ADDENDUM NO.: ONE DATE: 05 April 2012

PROJECT TITLE: HORIZON CENTRAL GAS PIPING AUGMENTATION

Horizon I Research Facility University of South Carolina State Project No. H27-I966

Ground Floor Methane Process Piping

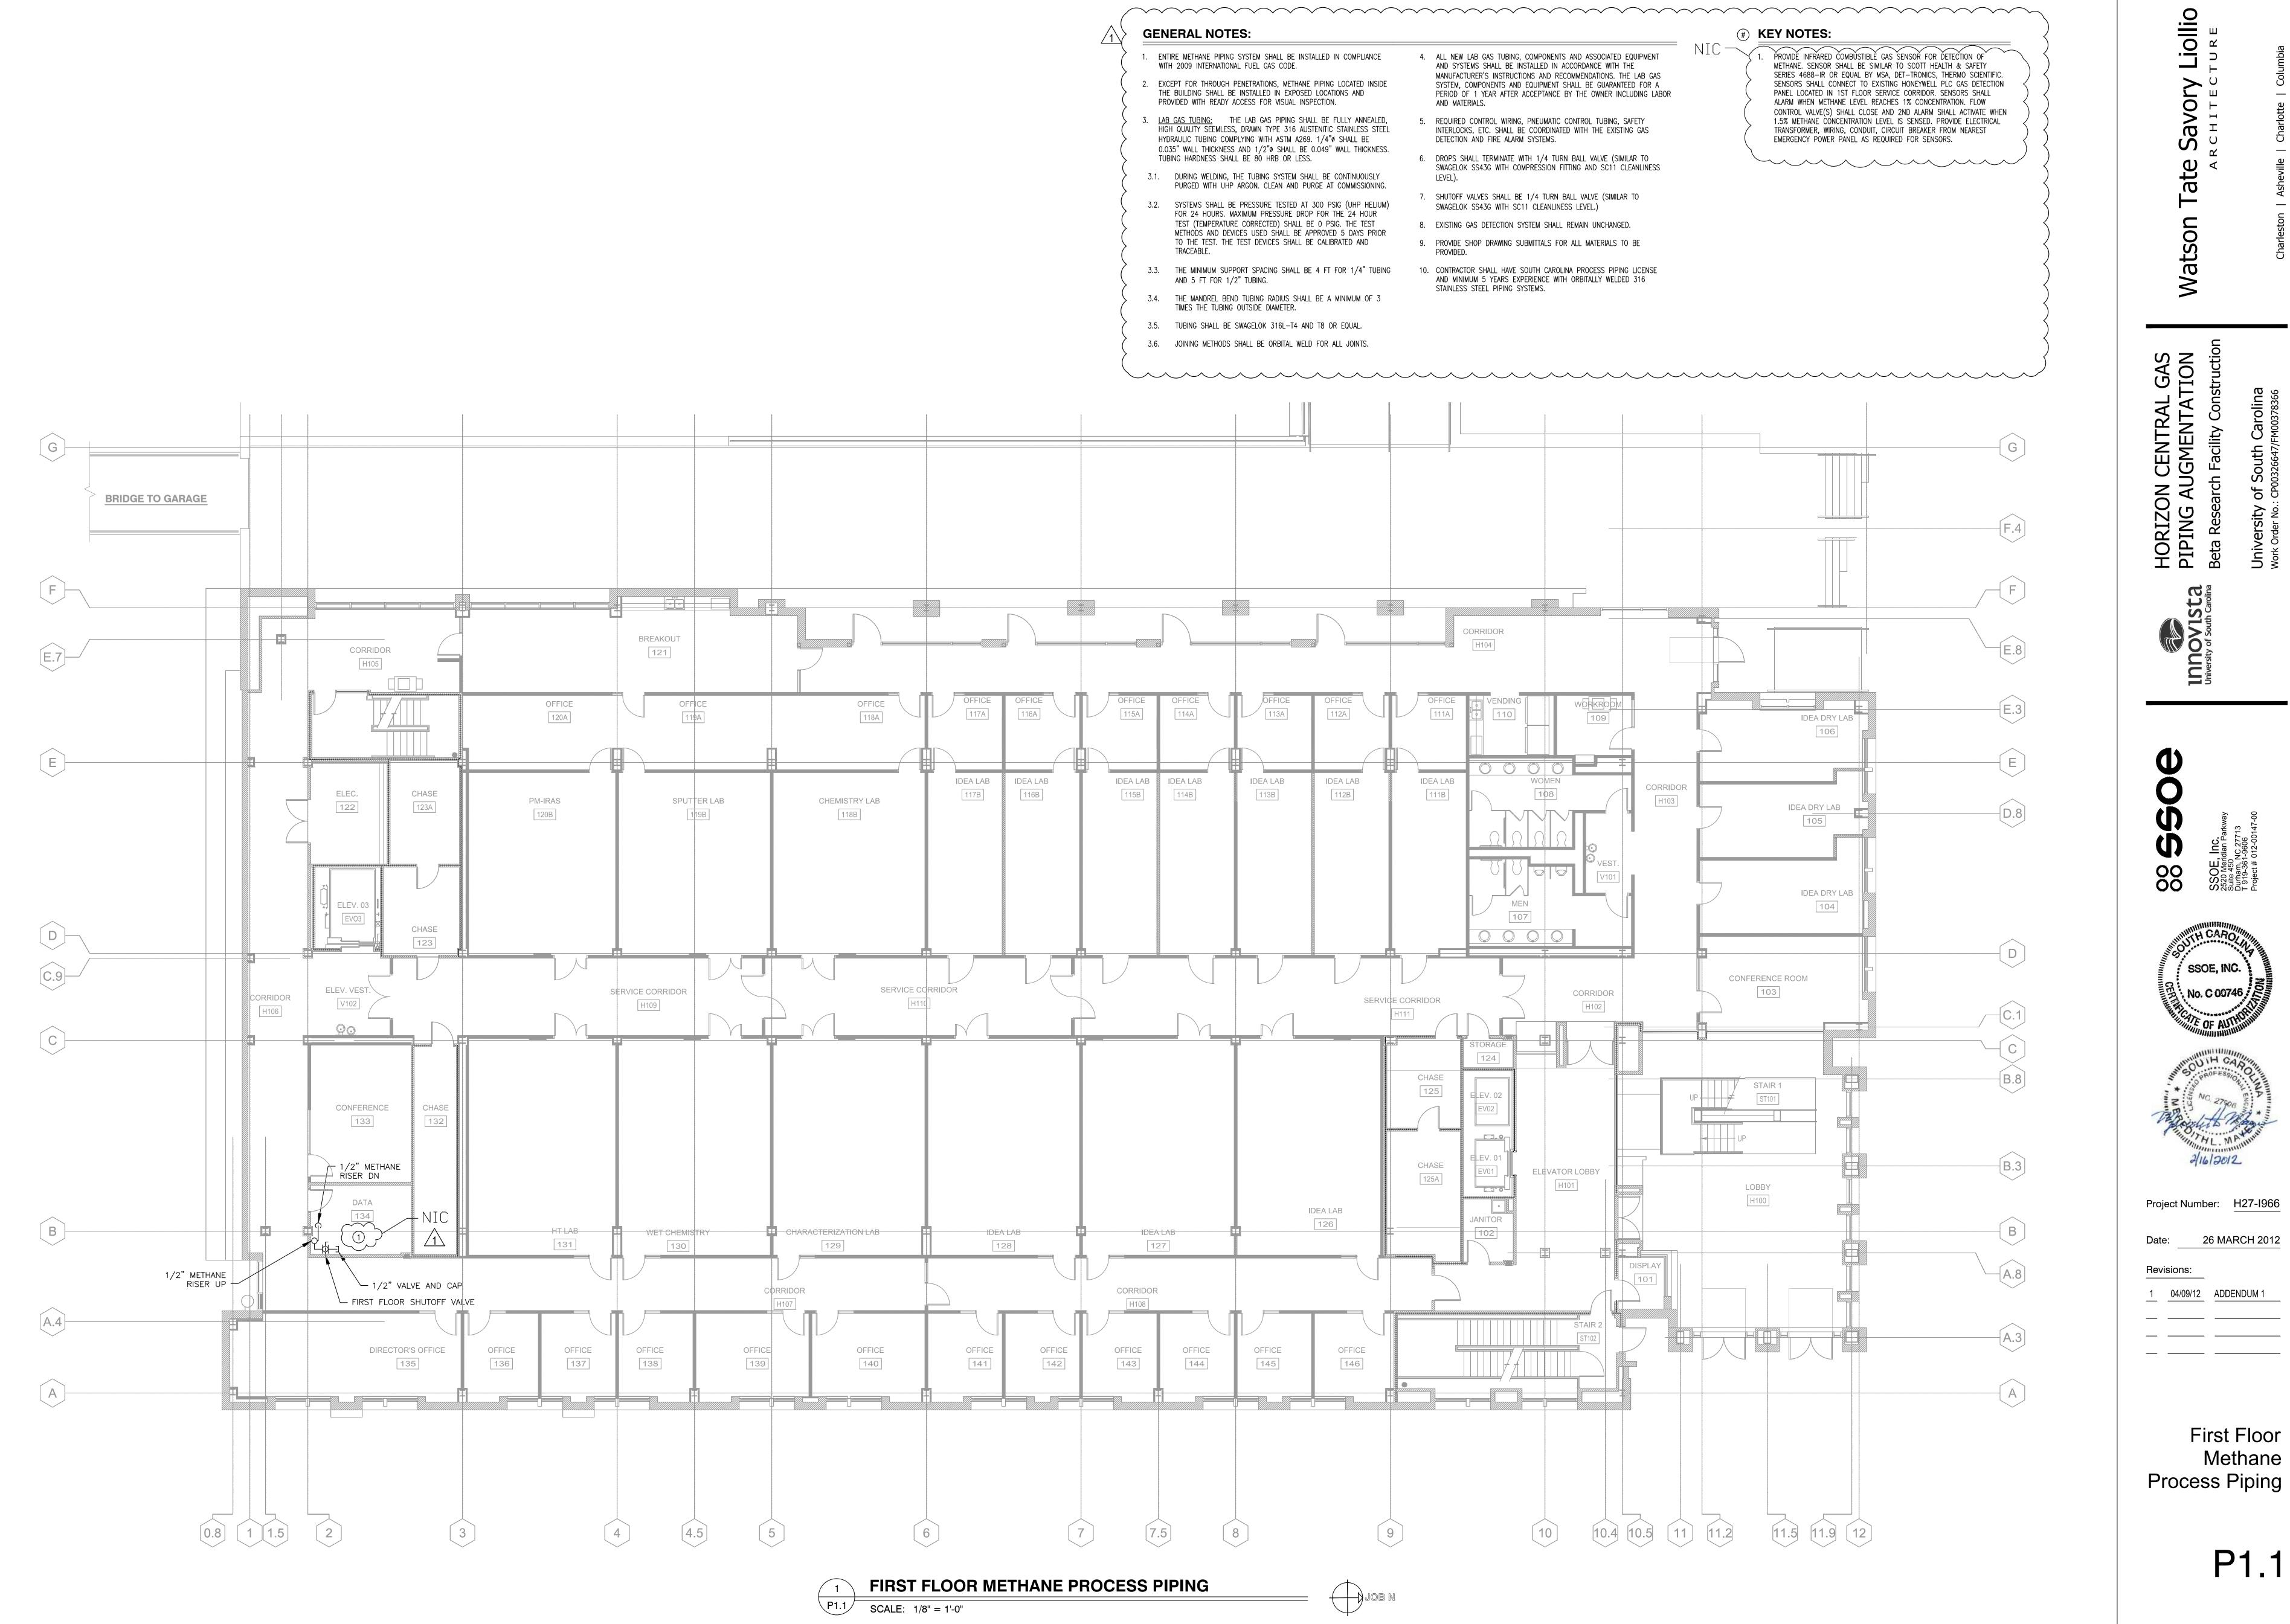
- DRAWING P1.0 GROUND FLOOR METHANE PROCESS PIPING: DRAWING P1.1 – FIRST FLOOR METHANE PROCESS PIPING: DRAWING P1.2 – SECOND FLOOR METHANE PROCESS PIPING: DRAWING P1.3 – THIRD FLOOR METHANE PROCESS PIPING:
 - A. Replace these drawings with the attached revised Drawings P1.0, P1.1, P1.2 and P1.3, noted with Revision date of 04/09/12 for Addendum No. 01. Revisions have been shown clouded.

THIRD FLOOR METHANE PROCESS PIPING SCALE: 1/8" = 1'-0"

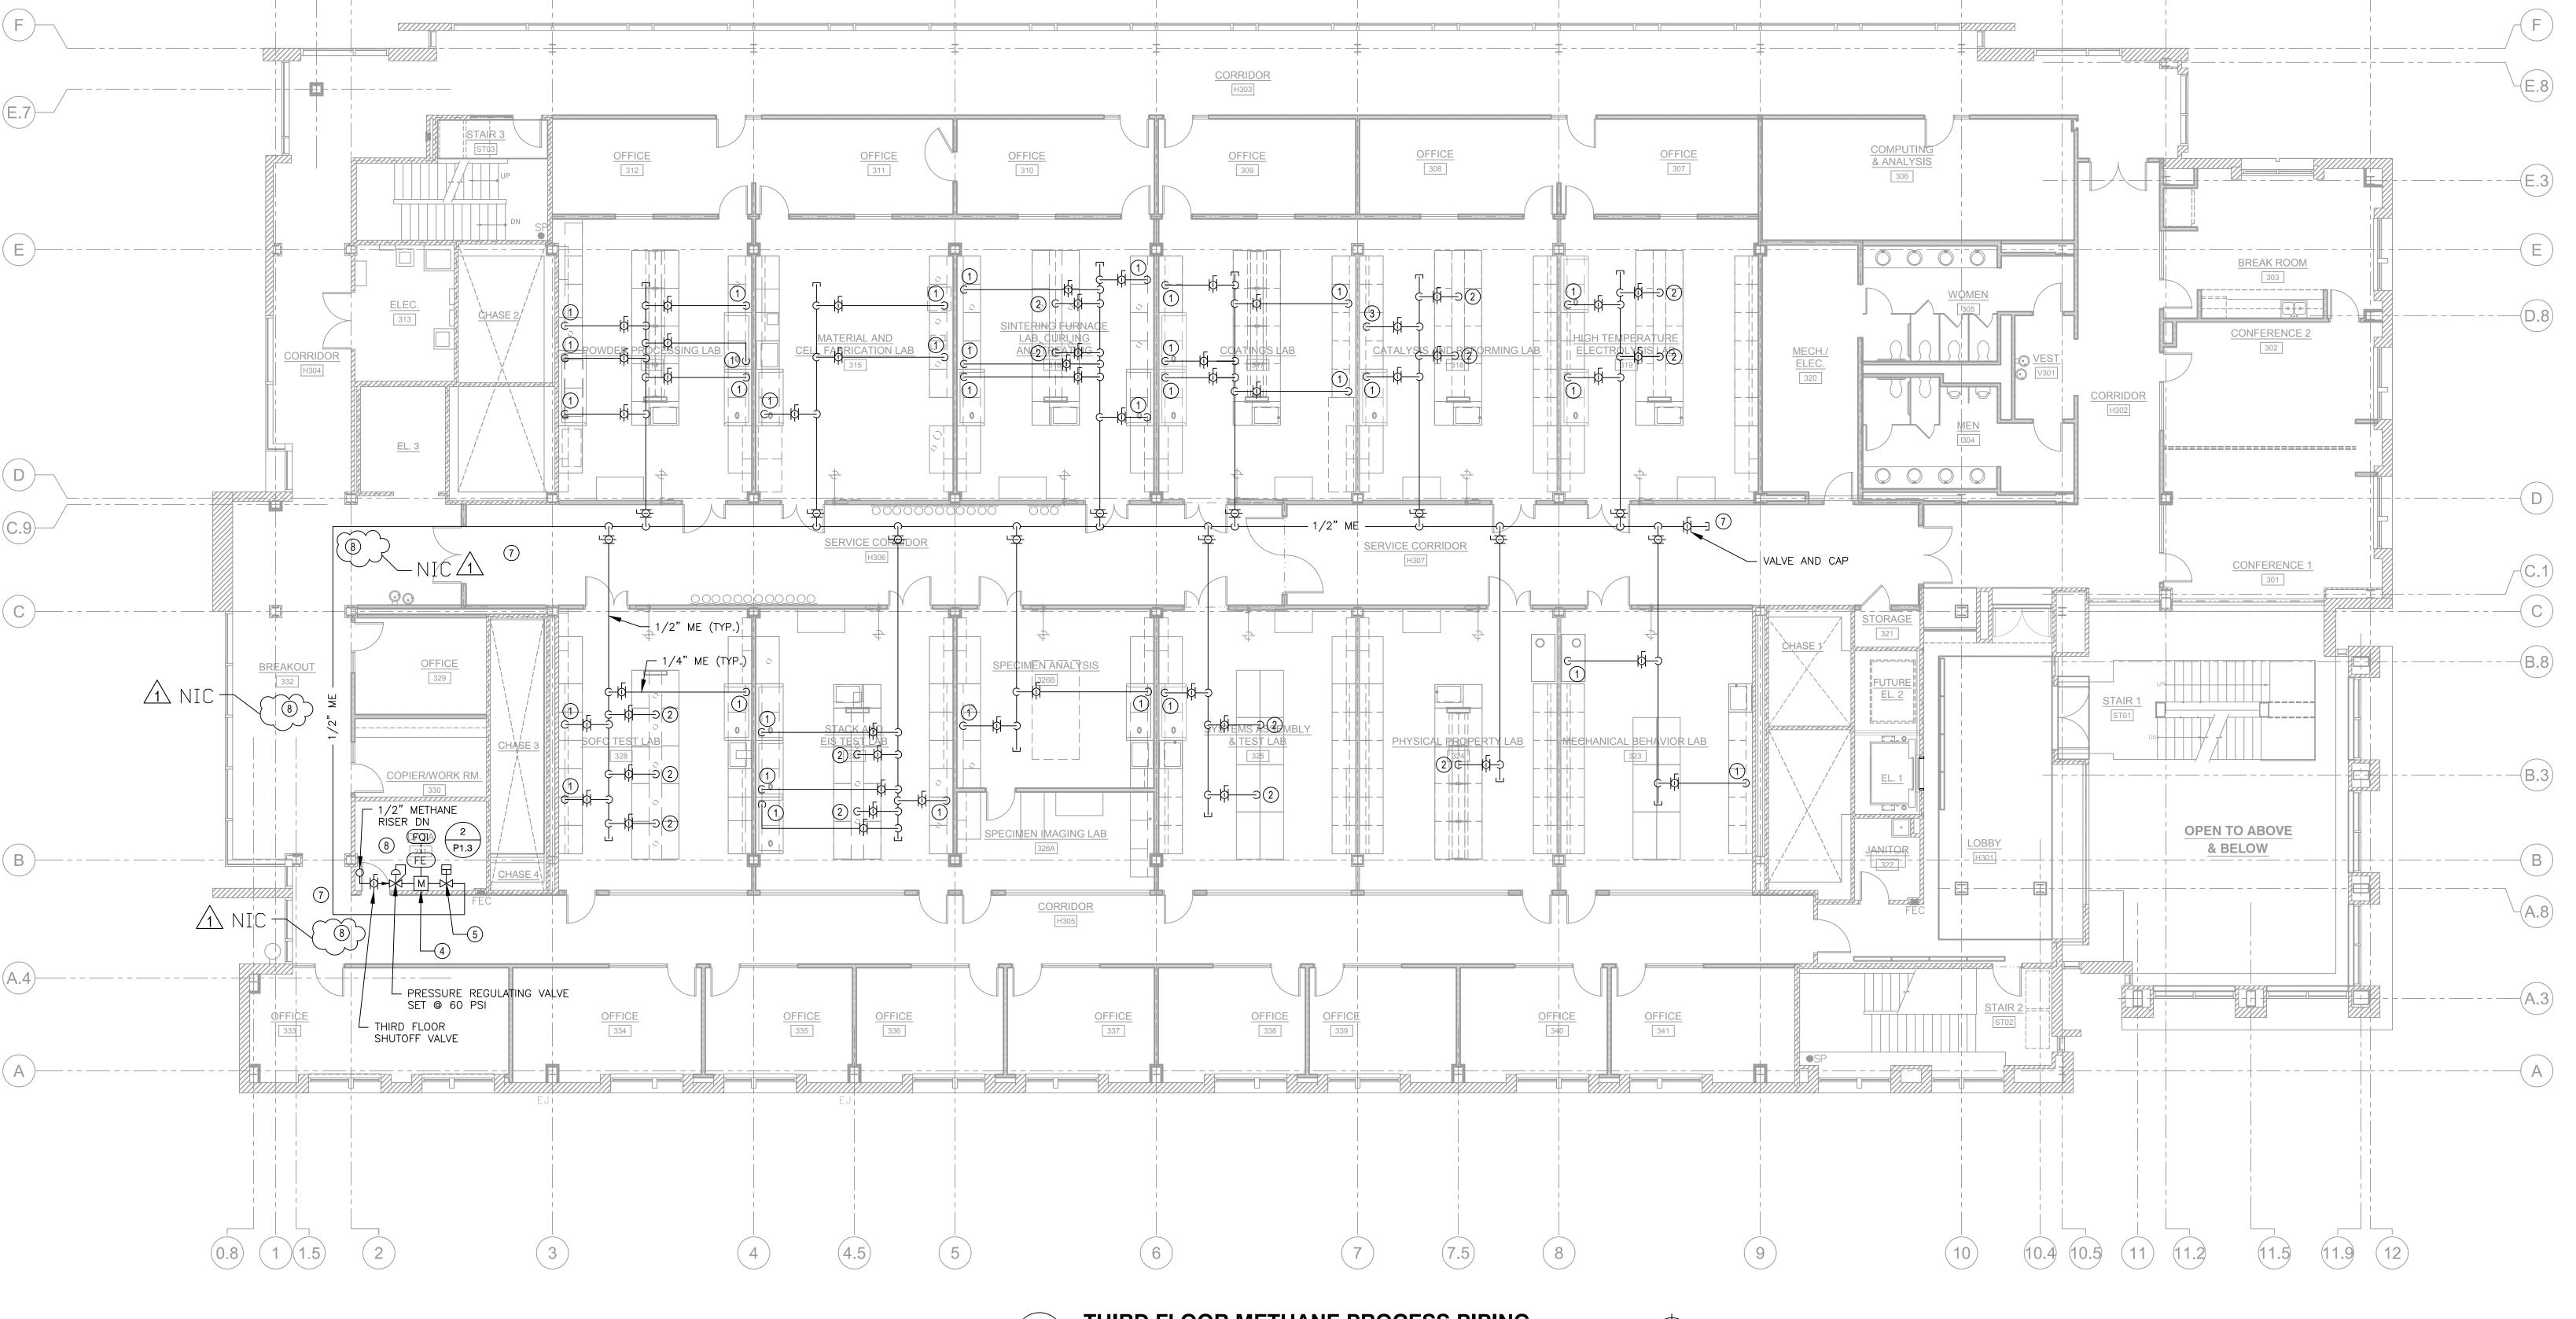
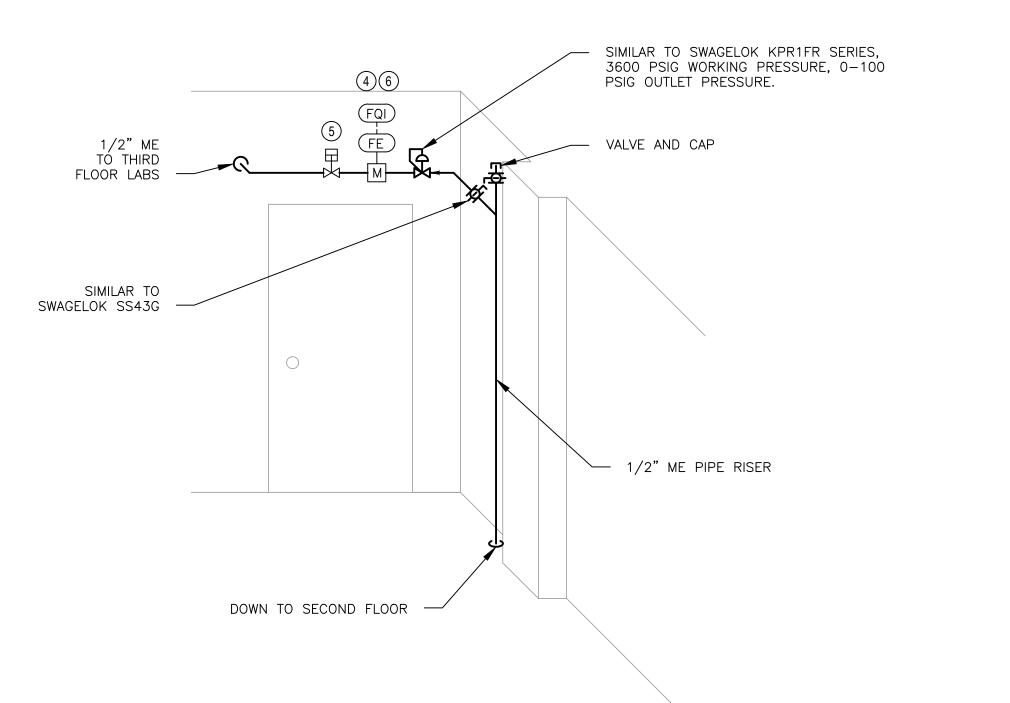
- 1. Is the pressure at the drops 100 psig as shown for the riser? Same 100 psig as the risers.
- 2. Is it required to only have 1 line down the service corridor with branches taking off left and right into the labs at Third Floor or can lines run down either side of the corridor as was done with the hydrogen? Either 1 line down the center or line on either side of corridor is acceptable.
